Washington Village
Norwalk, Connecticut
FMC/FME 2014-01124

Response to CTDEEP Comments

July 24, 2014

Re: **Washington Village, Norwalk
Clarification of CTDEEP Comments**

RAYMOND STREET
ROADWAY PLAN
AND PROFILE

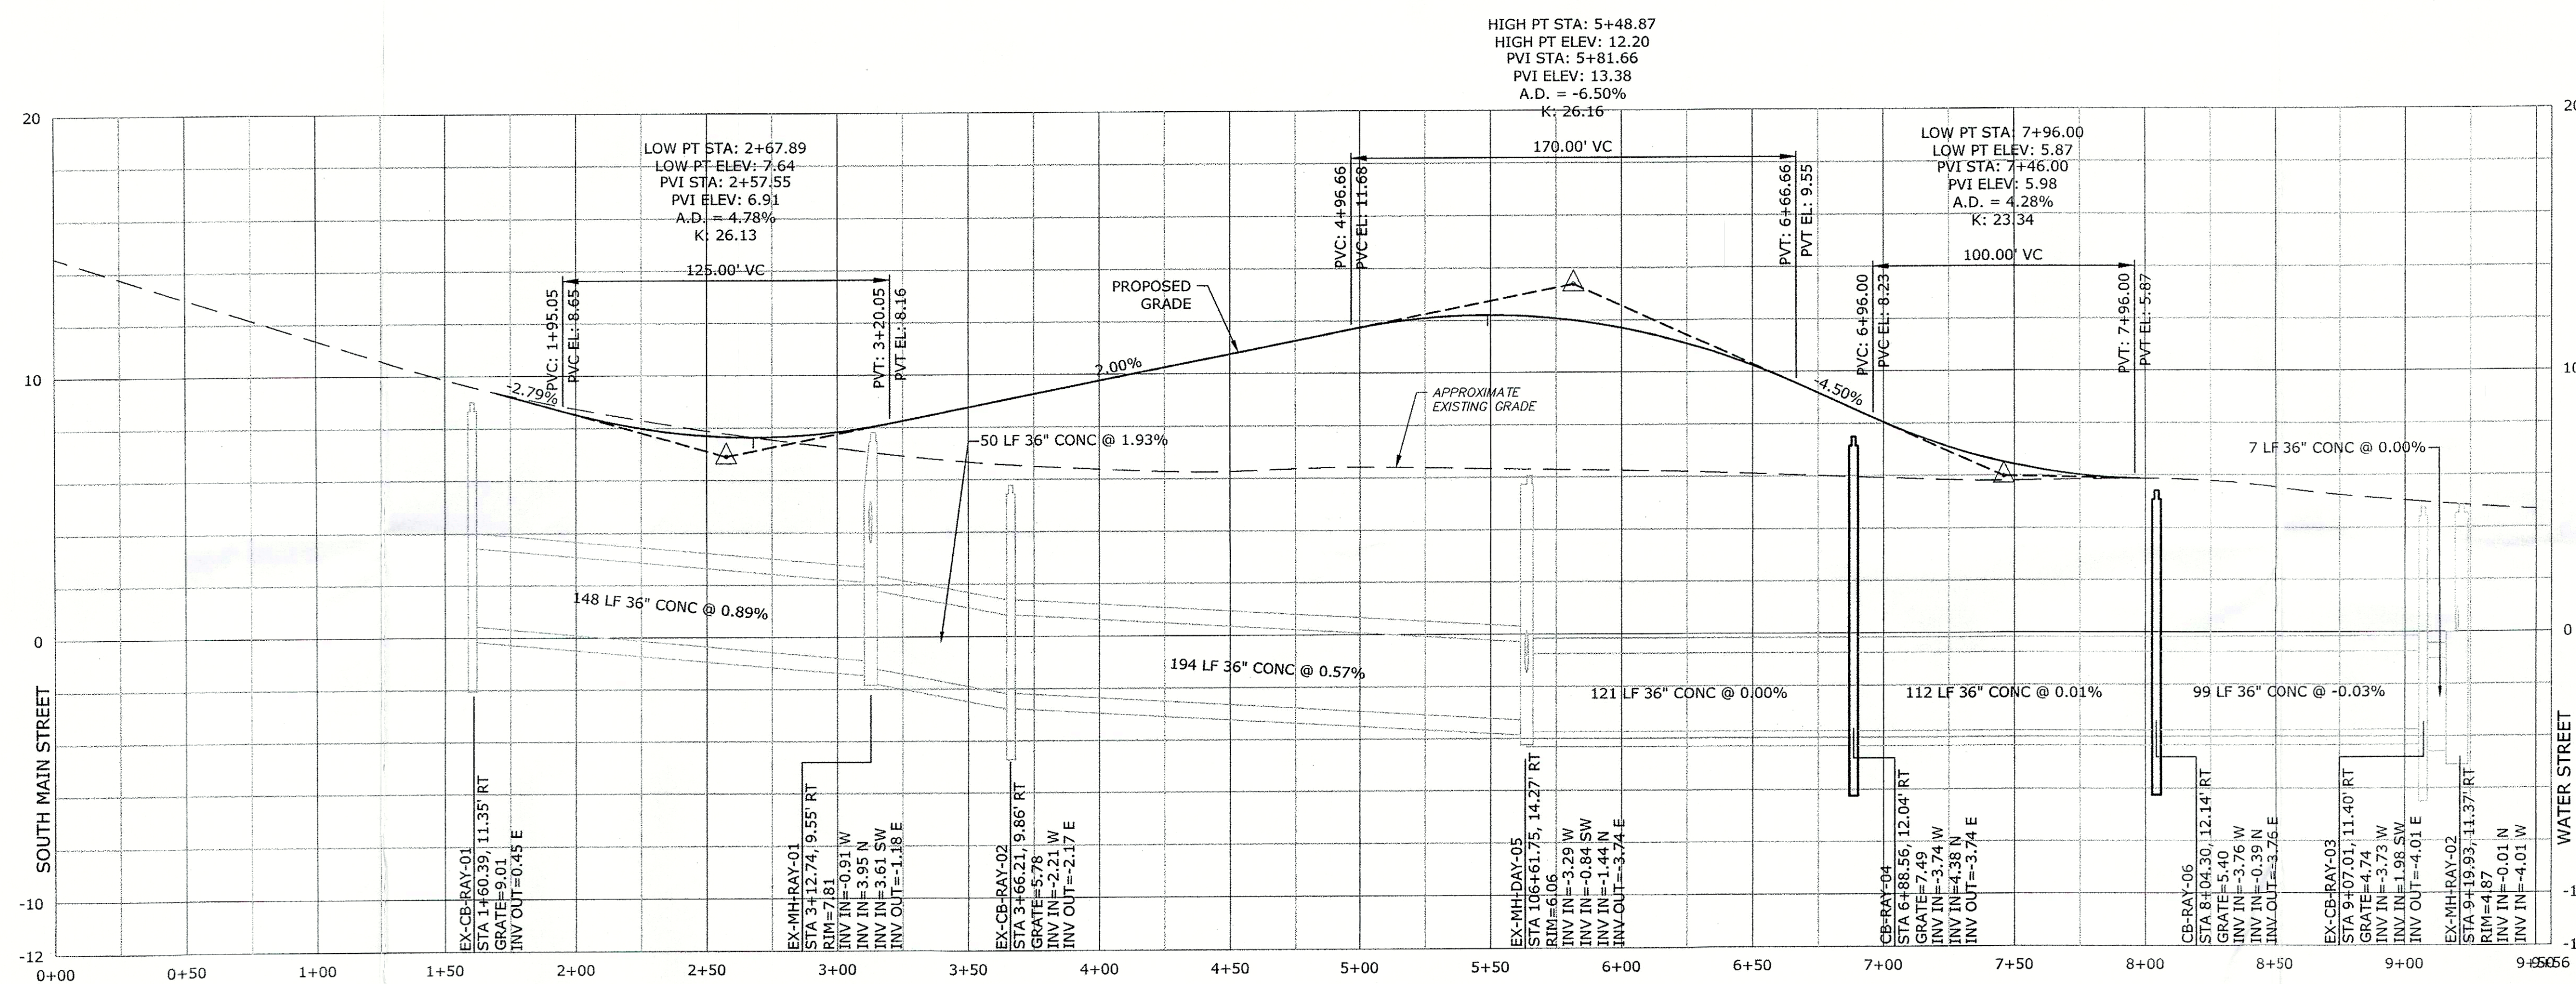
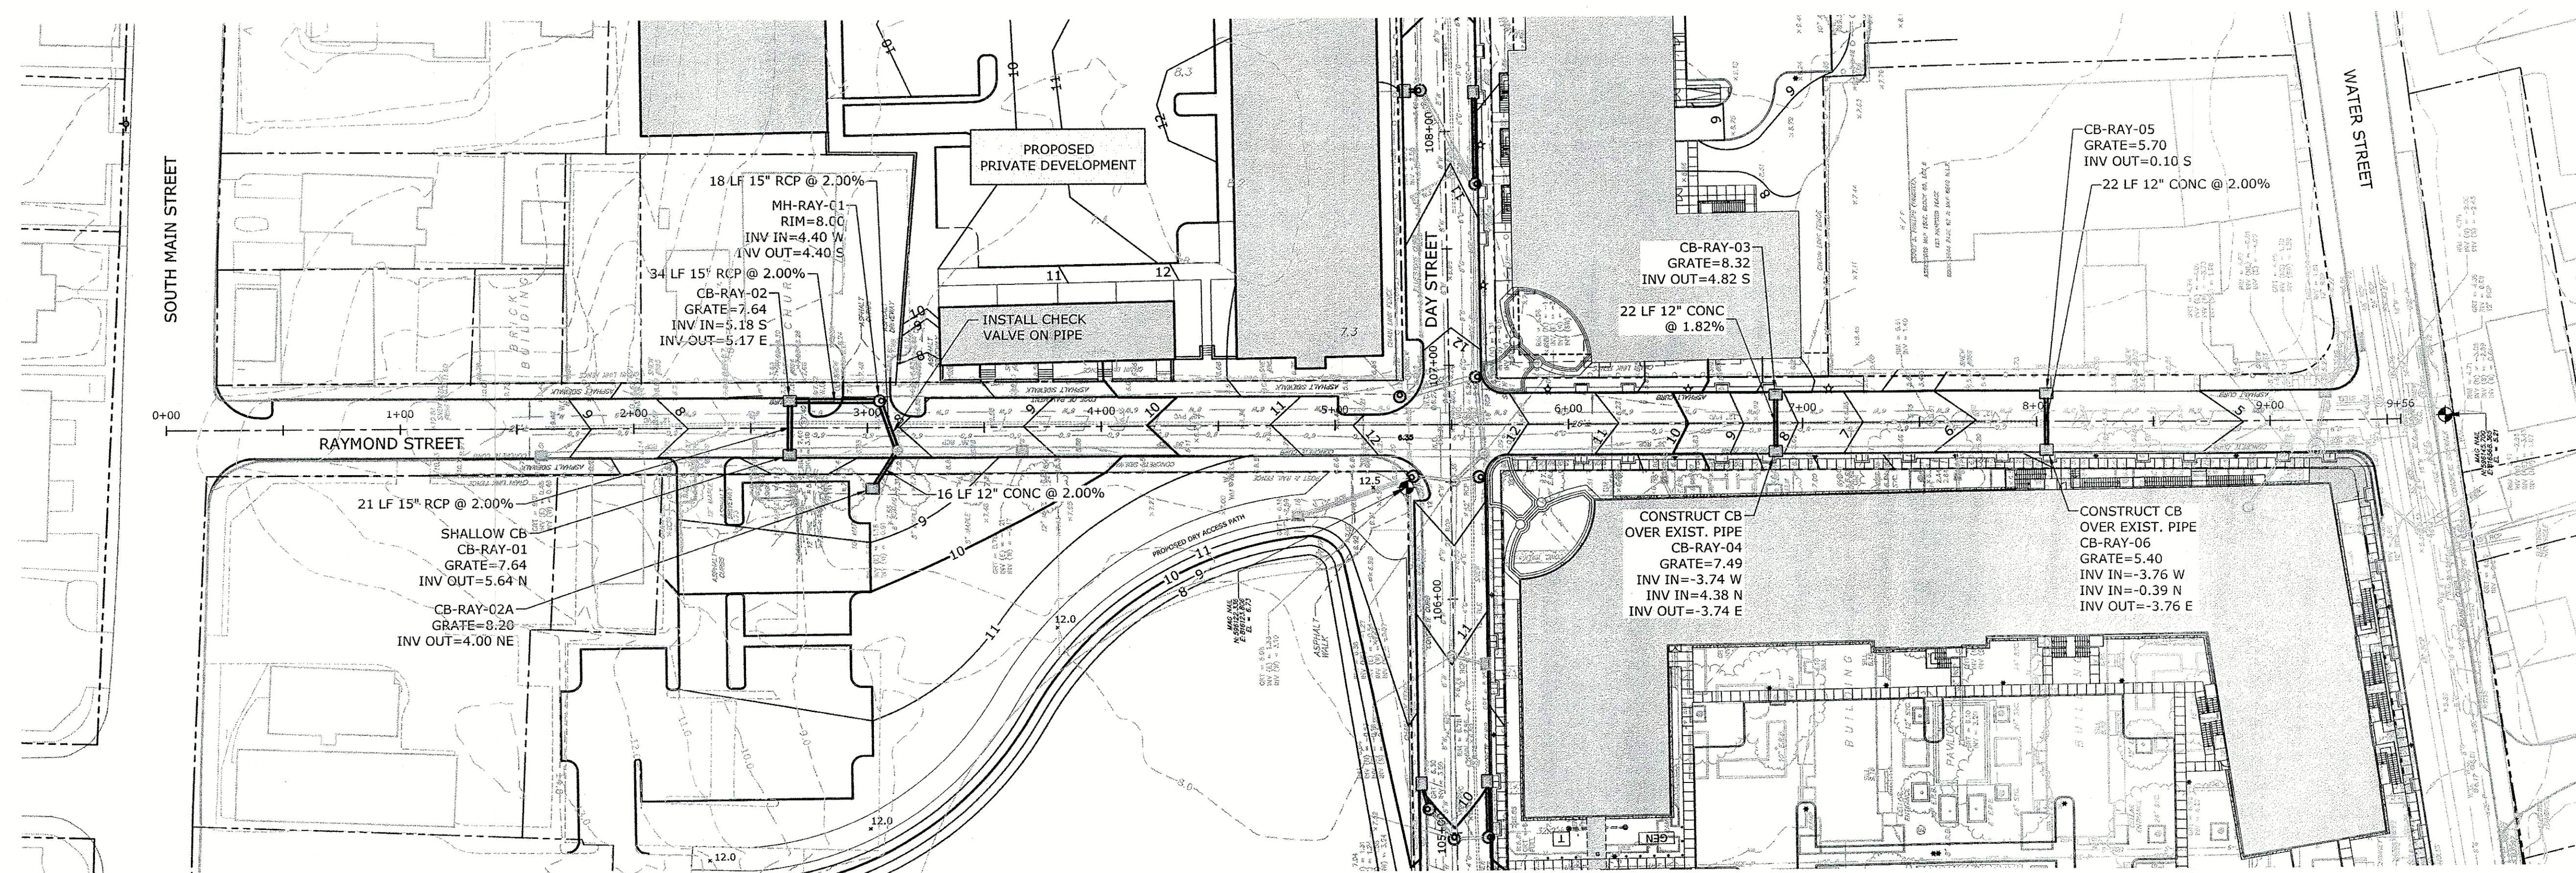
- **Updated drainage plan and profile of Raymond and Day Streets, including more information on location of drainage structures.**
 - PP.01 Raymond Street Roadway Plan and Profile
 - PP.02 Day Street Roadway Plan and Profile – 1
 - PP.03 Day Street Roadway Plan and Profile – 2
